<b>DART</b> AEROSPACE	
TITLE	
ENGINE WASH UNIT	
DWG NO.	
HT-500-CWA	
REV 10	
MAT'L	
UNLESS OTHERWISE SPECIFIED DIMENSIONS ARE IN INCHES	
HEAT      XXX $\pm$ .005      FRACTIONS $\pm$ 1/8	
TREAT      XX $\pm$ .01      ANGLES $\pm$ 5°	
FINISH      X $\pm$ .1      SURFACES = 125	
SPEC	
DRAWN BY: NELSON	
CHECKED: DUERFELDT	
OPPS APPR: ANDERSON	
QA APPR: LINDSAY	
APPROVED: GILBERT	
SCALE	1:10
DATE	7/15/2014
SHEET 3 OF 32

## WORK ORDER NON-CONFORMANCE / UPDATE

AIR TANK CRADLE

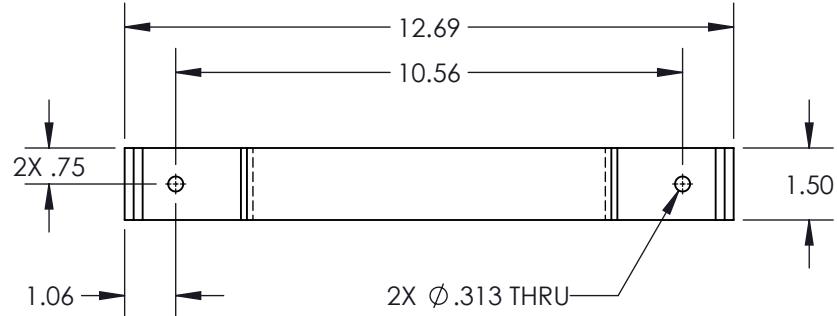
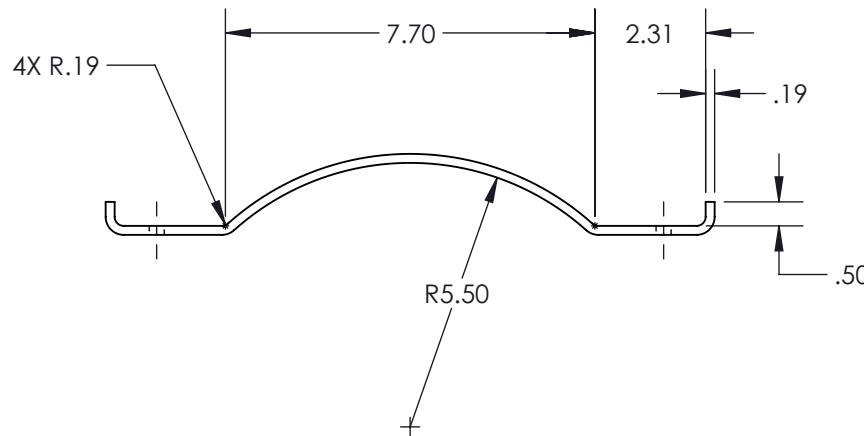
REVISIONS		
REV	ECR		DESCRIPTION	DATE	INITIAL
7	14-0131		<b>-017</b> ADDED MISSING DIMS 1.06, 4X R.19, CH'D DIMS WAS 7.75 IS 7.70, WAS .188 IS (.188).	7/28/2014	DPD
9	16-0205		.017 CH'D DIMS WAS (.150) IS 1.50, WAS (.188) IS .19, WAS (1.69) IS 1.69, CH'D DWG TO SHEET METAL TOLERANCE.	11/21/2016	RJC

AIR TANK BANDS

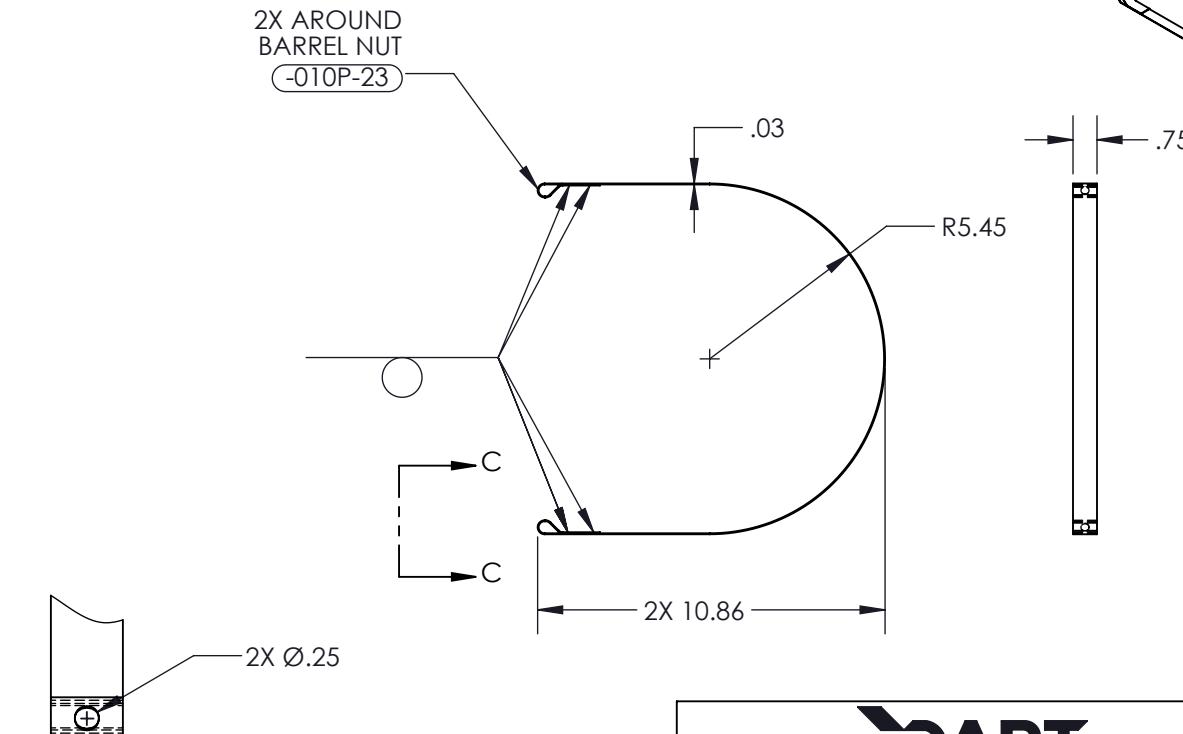
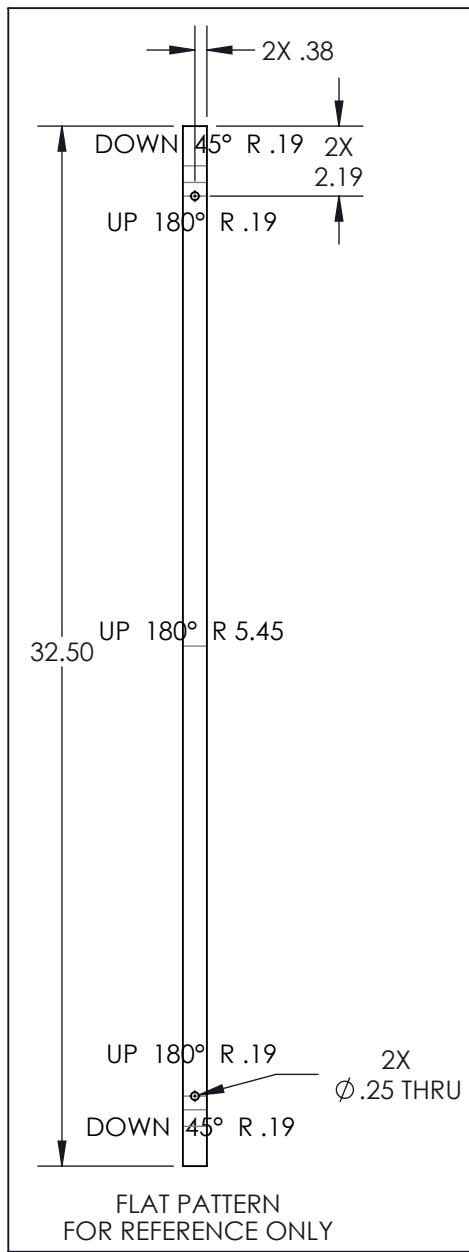
REVISIONS			
REV	ECR		DESCRIPTION	DATE	INITIAL	APPROVED
9	16-0205		-018 CH'D DIM WAS (.031) IS .03, WAS (.75) IS .75, ADDED DIMS R5.45, 2X 10.86, ADDED VIEW C-C, CHD DWG. TO SHEET METAL TOLERANCE.	11/21/2016	RJC	JAG

CONTROL BOX

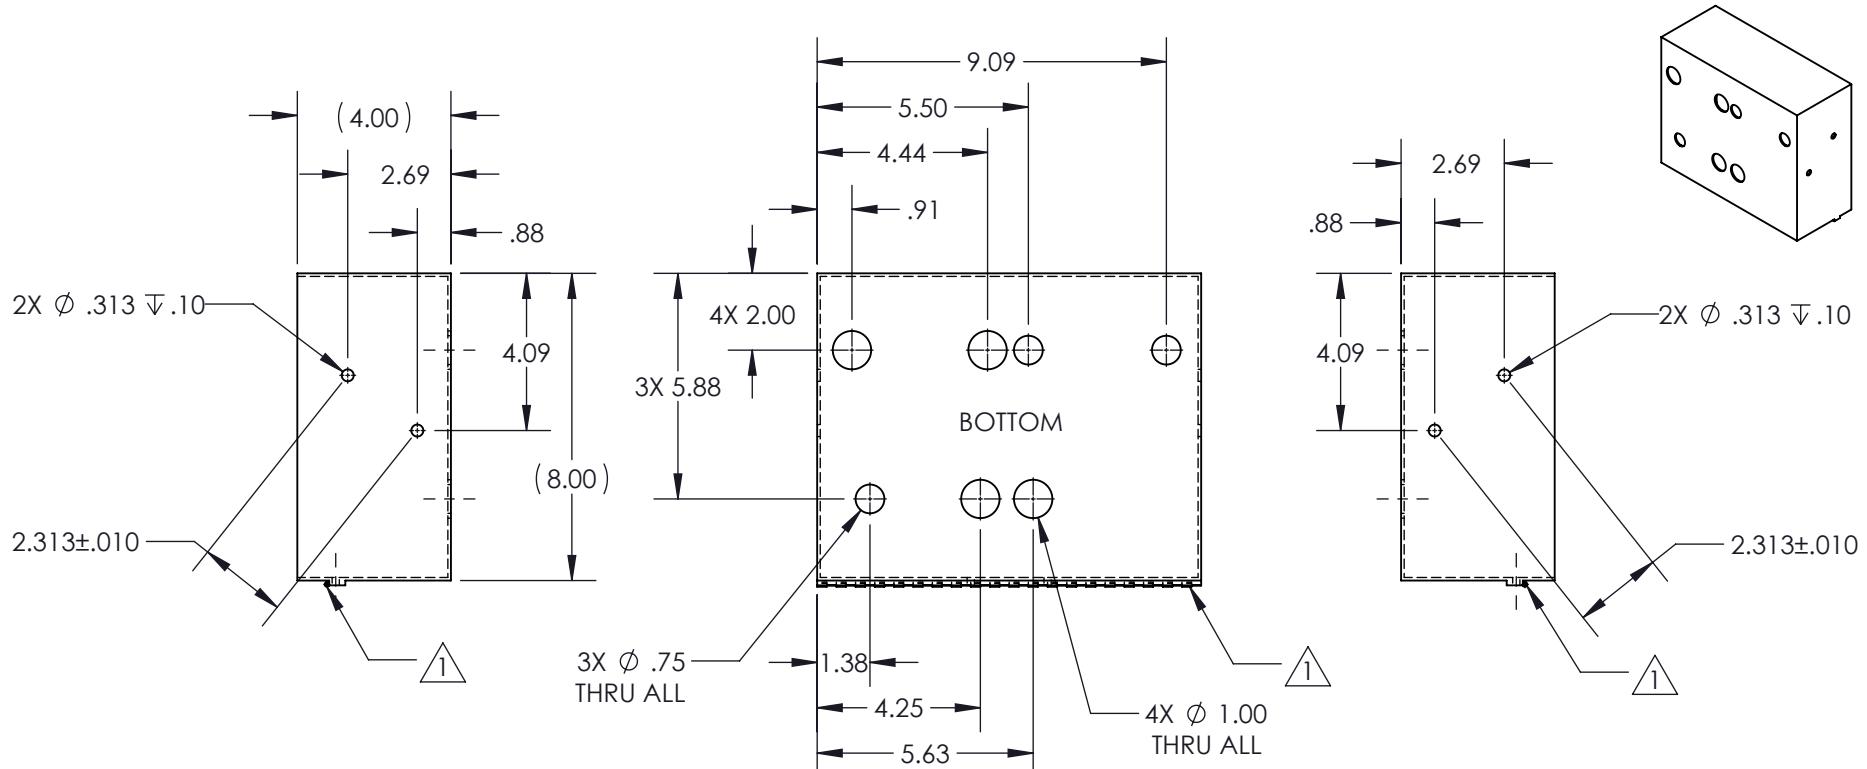
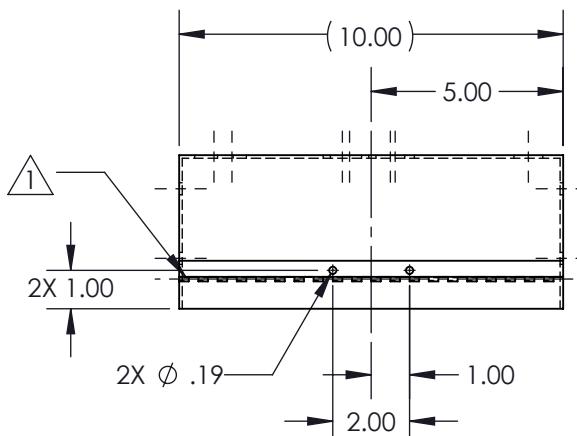
REV			ECR			DESCRIPTION			REVISIONS		
									DATE	INITIAL	APPROVED
7	14-0131		-010P-01	CH'D DIM WAS 3X Ø.81 IS 3X Ø.75.					7/28/2014	DJN	RJC
9	16-0205		-010P-01	DELETED DIM 2.66, ADDED DIM 2.313 ±.010, CH'D DIM WAS 2X Ø.313 THRU ALL IS 2X Ø.313 Ø.10.					11/21/2016	RJC	JAG

HINGE STOP

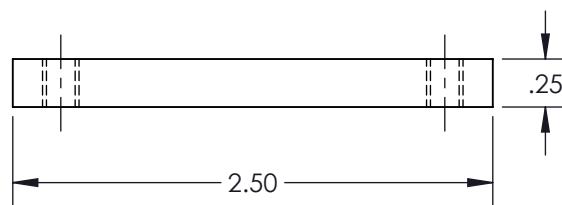
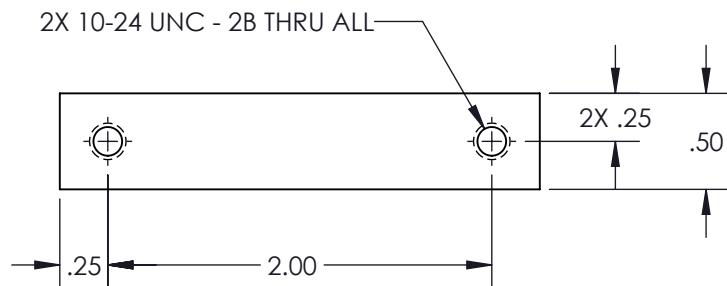
REVISIONS					
REV	ECR	DESCRIPTION	DATE	INITIAL	APPROVED
7	14-0131	-010P-03 CH'D DIMS WAS .25 IS 2X .25, WAS .25 IS (.25).	7/28/2014	DJN	RJC
9	16-0205	-010P-03 CH'D DIM WAS (.25) IS .25, ADDED FINISH CLEAR ANODIZE MIL-A-8625F-TYPE II CLASS I.	11/21/2016	RJC	JAG

PANEL PLATE

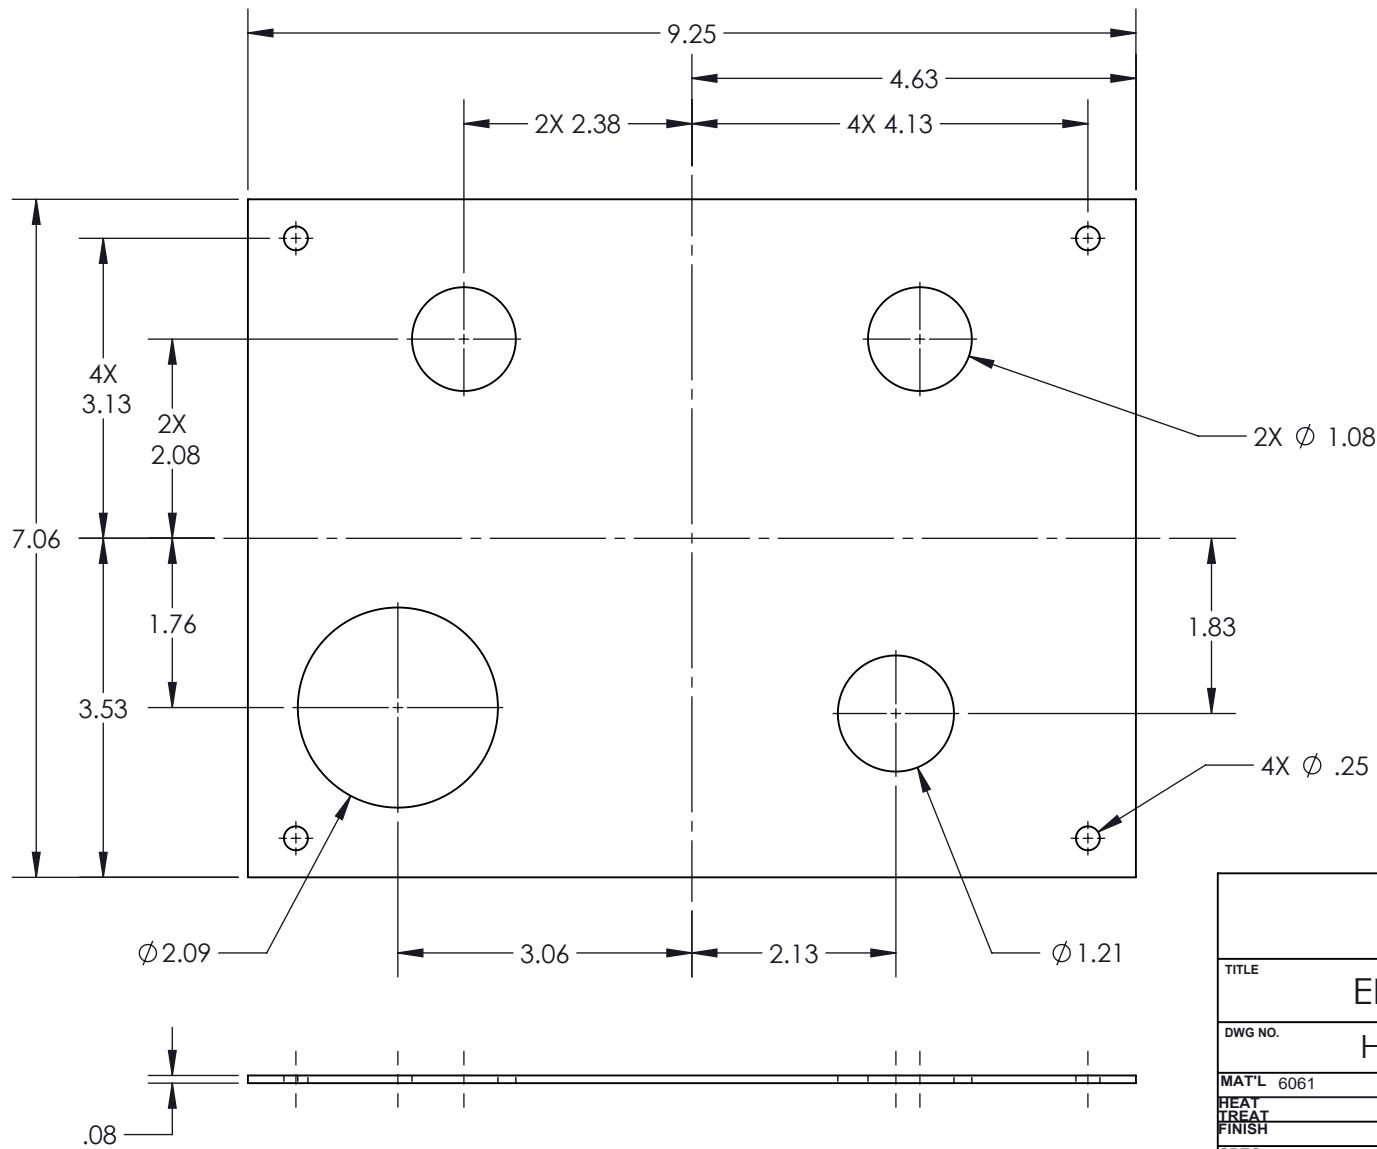
REV			ECR			DESCRIPTION			DATE			INITIAL			APPROVED		
9	16-0205		-010P-04 CH'D DIM WAS (.08) IS .08.						11/21/2016			RJC			JAG

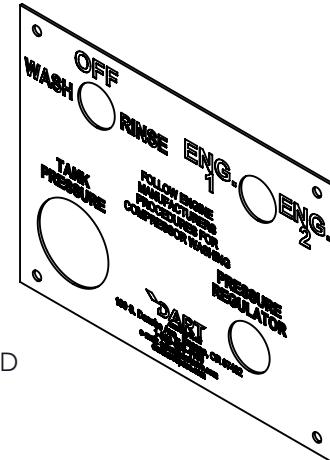
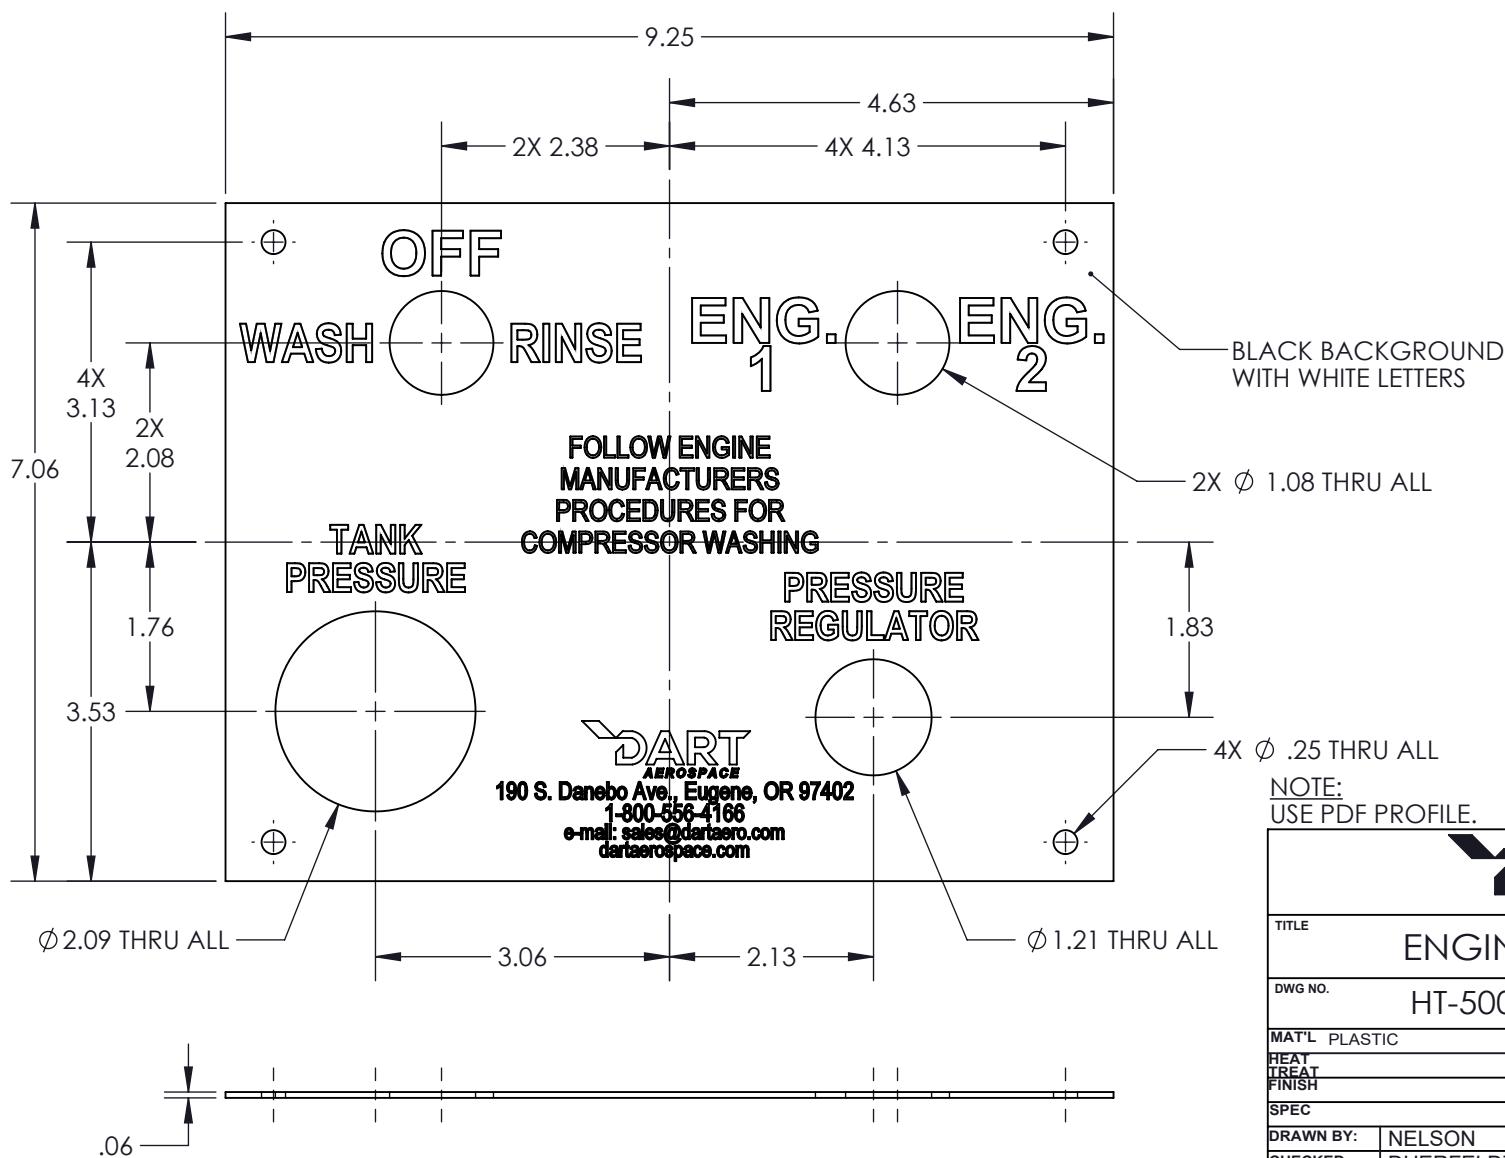
REVISIONS		
REV	ECR	DESCRIPTION	DATE	INITIAL	APPROVED
9	16-0205	-010P-05 DELETED DIM 4X .03 X 45°. CH'D DIM (.061) IS .06, WAS 2X Ø1.08 IS 2X Ø1.08 THRU ALL, WAS Ø2.09 IS Ø2.09 THRU ALL, WAS Ø1.21 IS Ø1.21 THRU ALL; WAS 4X Ø.25 IS 4X Ø.25 THRU ALL, CH'D NOTE WAS TOP IS TEXTURED BLACK WITH WHITE PLASTIC BACKING. ALL LETTERING IS CUT TO THE WHITE PLASTIC, ↓.02 IS BLACK BACKGROUND WITH WHITE LETTERS, CH'D P/N WAS ROWMARK #822422 IS (MULTI-CRAFT #LM922402), CH'D DWG TO SHEET METAL TOLERANCE.	11/21/2016	RJC	JAG
10	17-0058	-010P-05 CH'D DIMS WAS 2.08 IS 2X 2.08, WAS 3.13 IS 4X 3.13.	5/22/2017	DPD	JAG

THREADED ROD

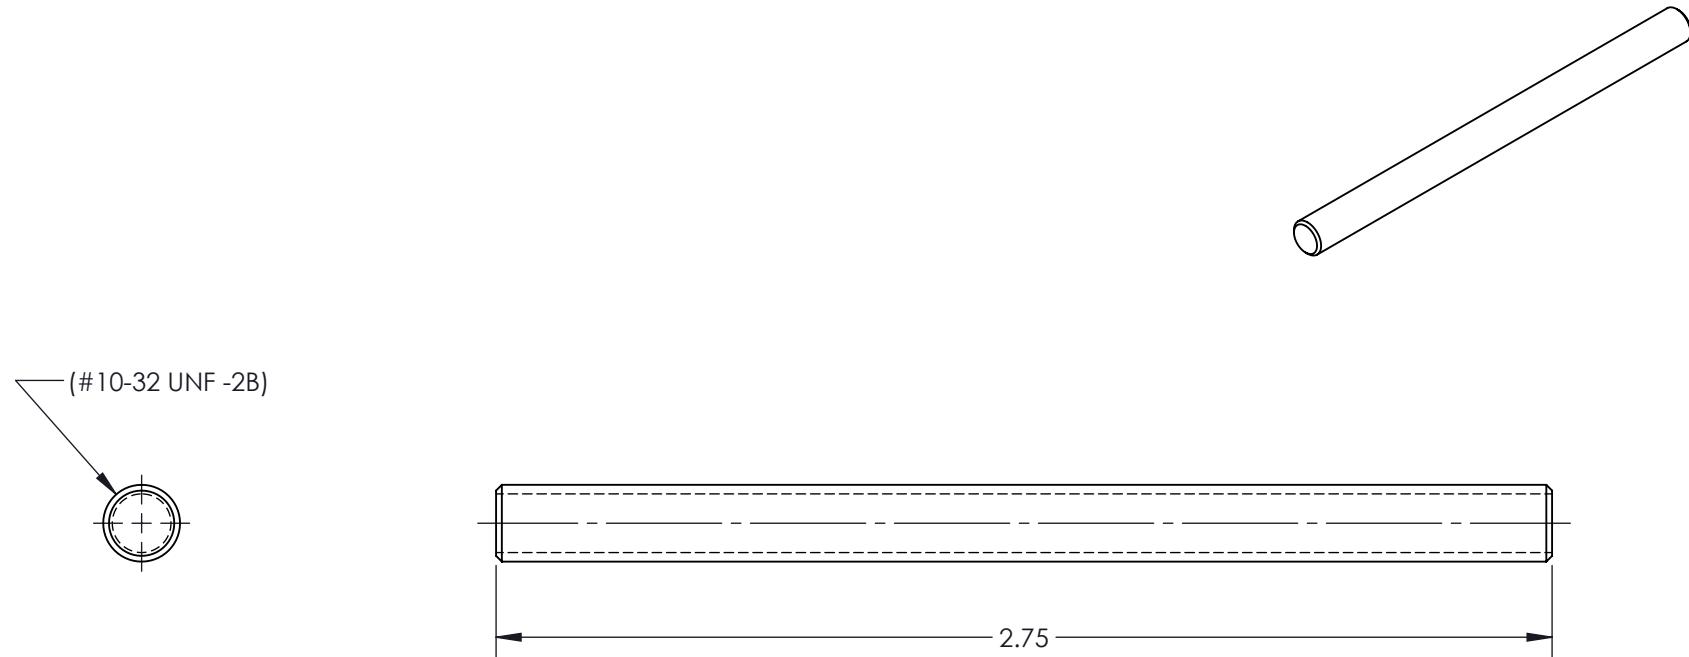
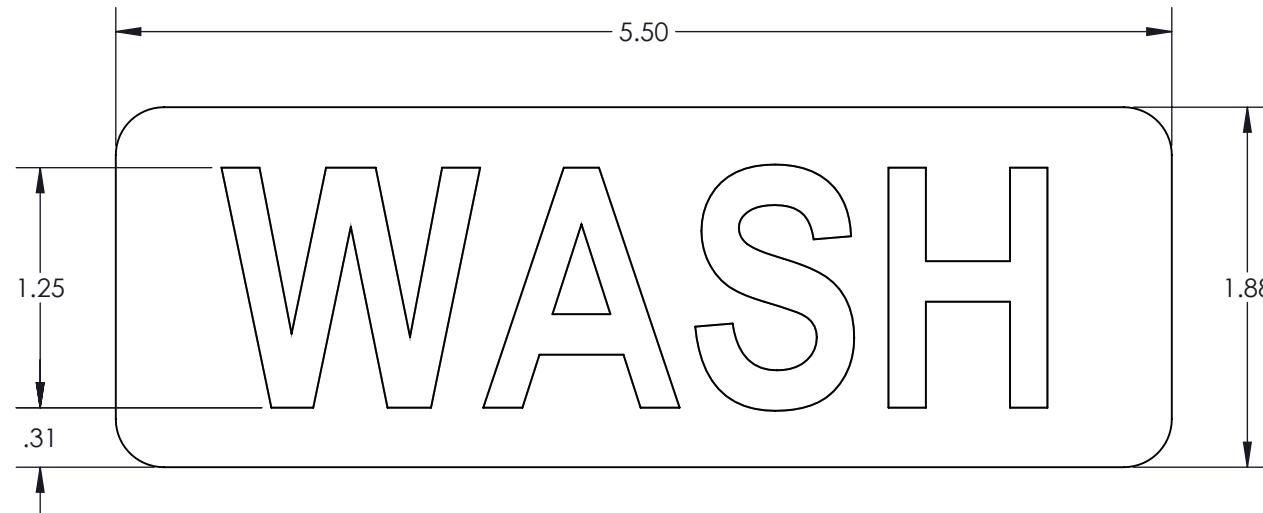
REVISIONS					
REV	ECR	DESCRIPTION	DATE	INITIAL	APPROVED
9	16-0205	-010P-19 ADDED DWG, CH'D B/O INFO WAS 10-32 X 2-3/4 MCMASTER-CARR #98921A011 IS 10-32 X 2-3/4 (MCMASTER-CARR #98921A011) MODIFIED.	11/21/2016	RJC	JAG
